MEMORANDUM

To: Downtown Design Board
From: Anne K. Bennett
Date: May 14, 2008
Re: Southeastern Glass Building (File #: 5-B-08-DT)

I have reviewed the proposed addition to the Southeastern Glass Building at the corner of W. Jackson and N. Broadway. In my opinion, the addition is an acceptable interpretation of the D-1 Design guidelines for the following reasons:

A5 EAST ELEVATION - NEW CONSTRUCTION

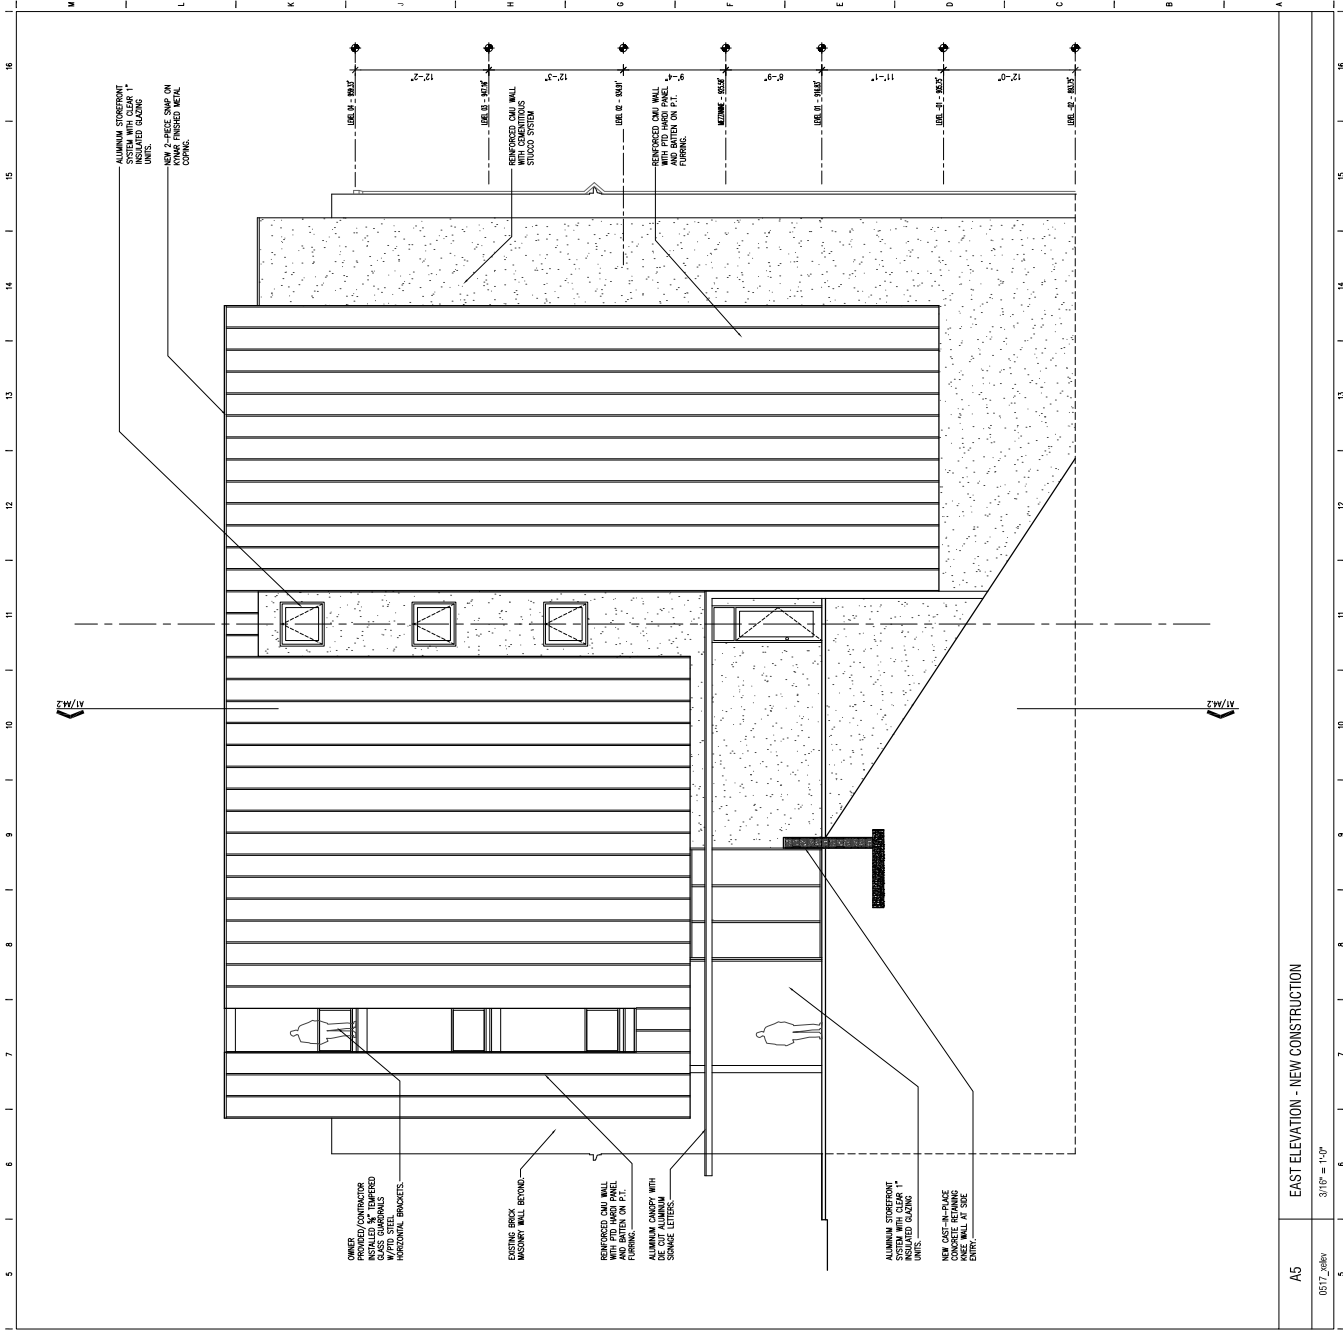
- 5) The ground floor (elevator/access stair) addition is necessary if the building is to be reused. It steps back from the existing building on W. Jackson, and is designed to be compatible with the existing building while still being a product of this era - a principal that is promulgated in the Secretary of Interior's Standards for Rehabilitation used to guide the reuse of National Register listed properties

A5 WEST ELEVATION - BROADWAY VIADUCT
0517_208w
3/16" = 1'-0"

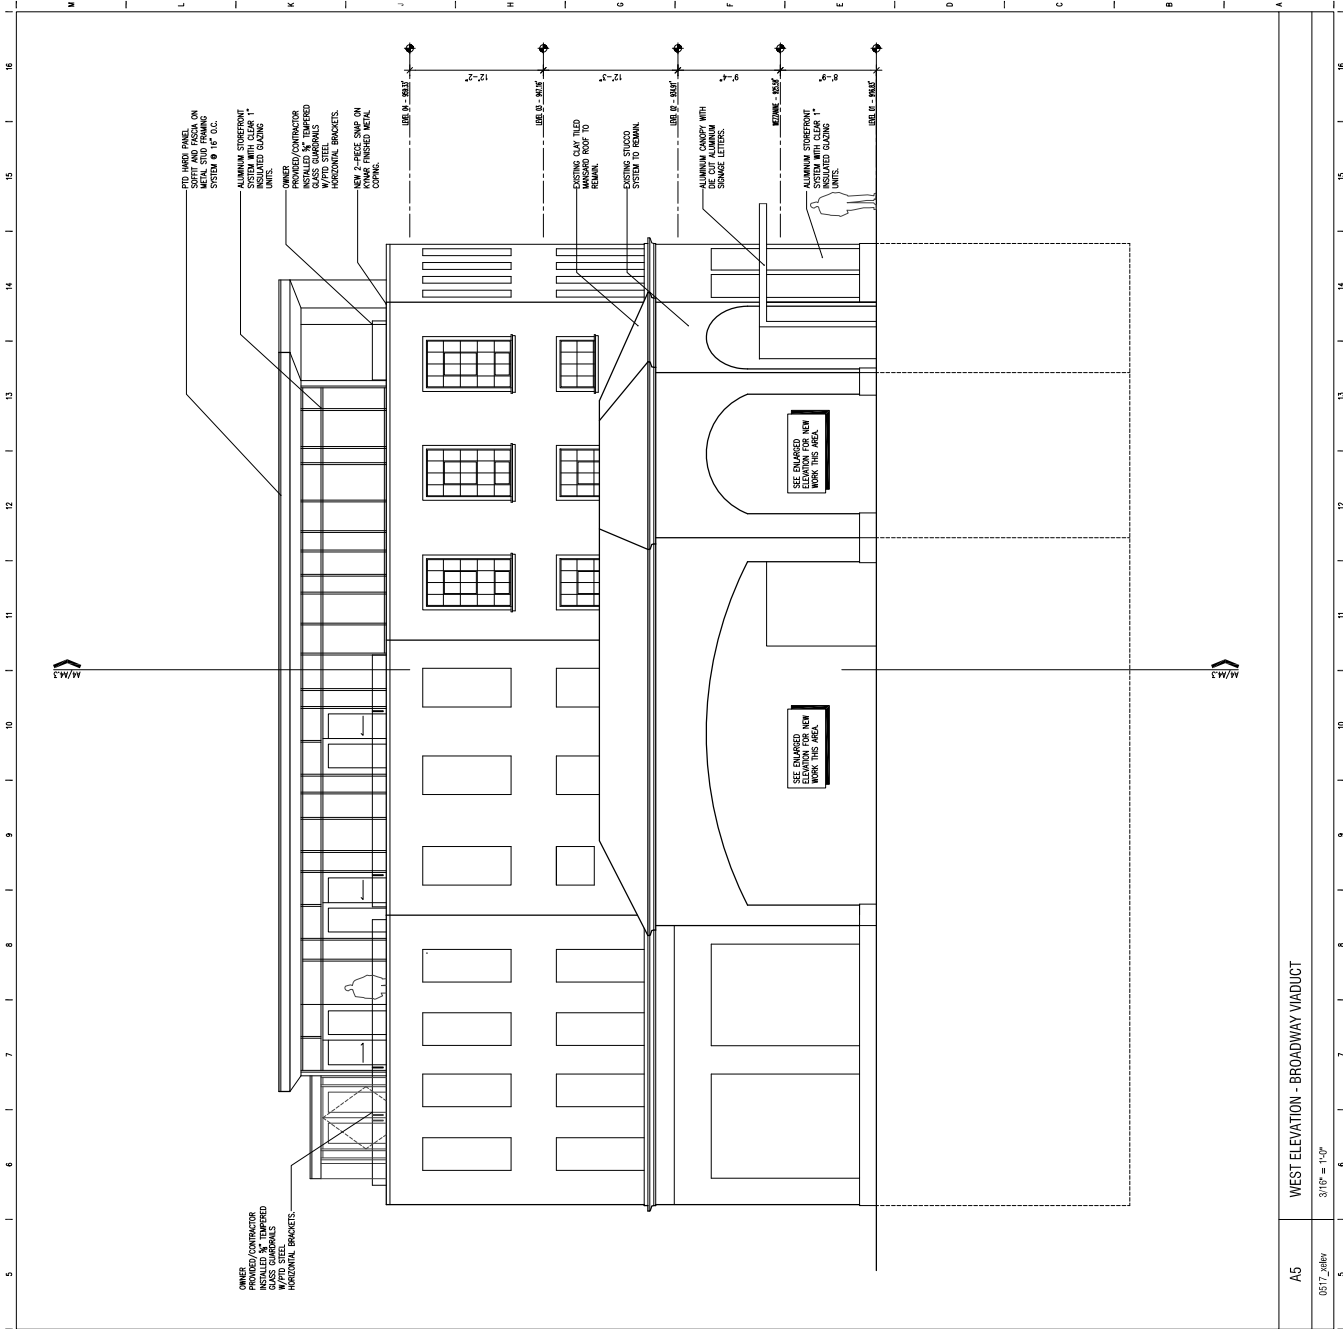
- 1) The SE Glass Building is a six story building on the north side and four (three plus a mezzanine) from the Jackson/Broadway street level.
- 2) The proposed roof addition is stepped back from the top story of the building, and adds another "terrace" to a building that already contains varying roof heights.

- 3) The proposed addition will not be taller than two mechanical or elevator roof additions now present on the building, both of which are utilitarian in design.

- 4) The illustrations of the additions show them to be white, and very obvious. This was done for purposes of illustration, and is not reflective of the final coloration of the additions, but the Design Review Board should take care to assure that the additions blend with the existing building materials in their final form.
